Metro Outer Joint Development Assessment Panel Agenda

Meeting Date and Time: Monday, 10 July 2023; 10.00am
Meeting Number: MOJDAP/257
Meeting Venue: Electronic Means

Figure 3: Vegetation Classification

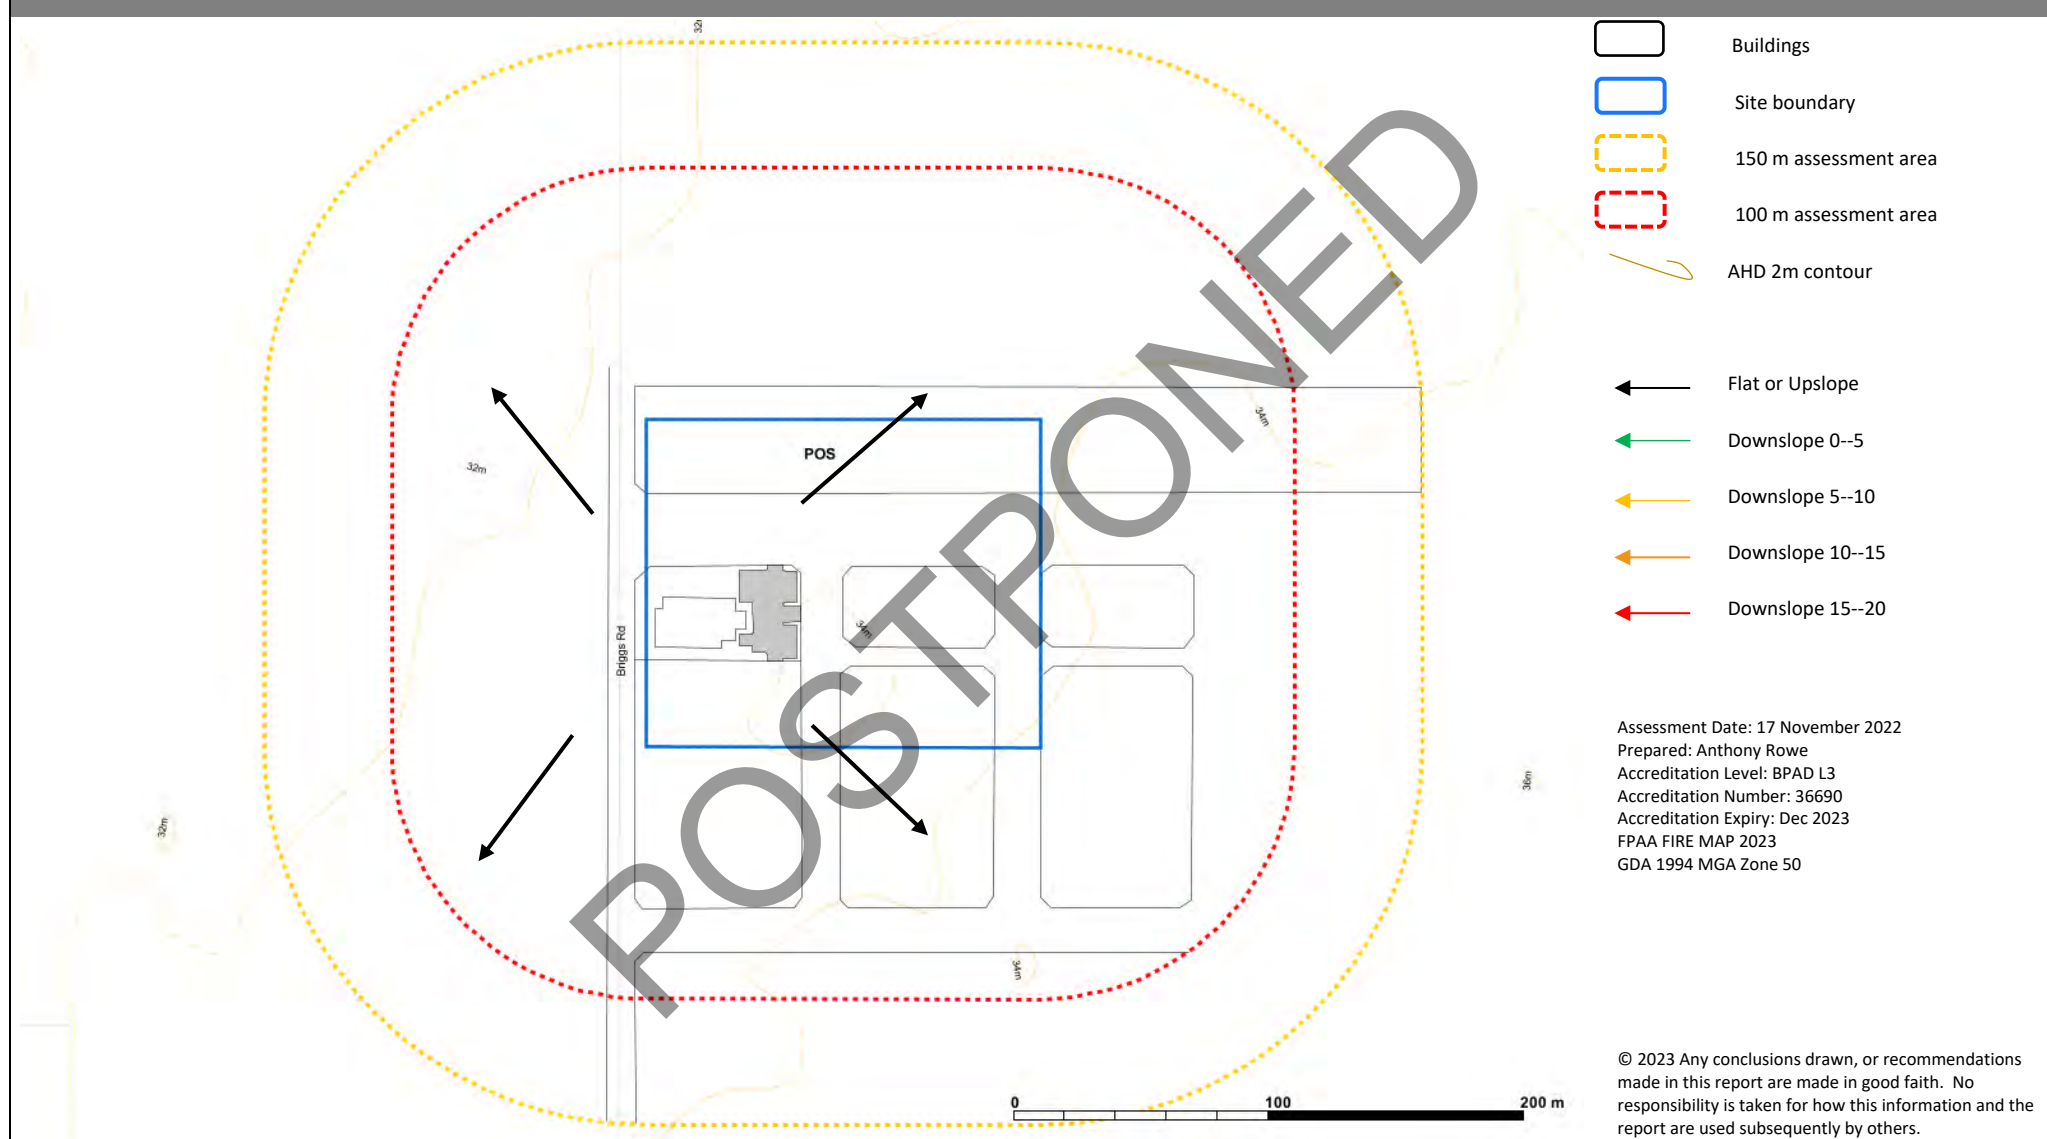
Issue	Assessment	Action
Vegetation Classification	<p>Figure 3 (Vegetation Classification) is difficult to interpret. In particular:</p> <ul style="list-style-type: none"> • The southern P1/Ex label appears to be out of position as it is located on an area classified as Grassland. Others may also be, which contributes to poor legibility; • Plot 2 and Plot 3 are difficult to distinguish with no clear outlines/boundaries; and • There are areas of vegetation within the area coloured as Grassland that are outlined separately and do not appear to be Grassland. Specifically the drainage reserve, trees to the east and west of Briggs Road, trees around the existing property and trees to the south of the proposed development site (discussed further below). 	Modification to the BMP is required

Submitter	No	Submitter Comments	Applicant Comment	Officer Recommendation
		<p>Figure 3 appears to combine both current classification and future (post development) classification. For clarity</p> <p>Noting comment above, vegetation Plots 2 and 3 cannot be substantiated as Class G Grassland in their entirety with the information and photographic evidence available.</p> <p>In particular:</p> <ul style="list-style-type: none"> • Photos 2.1 and 2.3 appear to show areas of mature trees around the development site, which do not appear to fit the classification of Class G Grassland; • Photo 3.1 does not clearly support Class G Grassland as the visibility is obscured by trees; • Photo 3.2 does not support the proposed classification as Class G Grassland. The drainage reserve appears to comprise Class A Forest vegetation. It is noted that the drainage reserve and the future Public Open Space to the north are described as Forest within the BMP (recognising the future state) 	<p>Modification to the BMP is required</p>
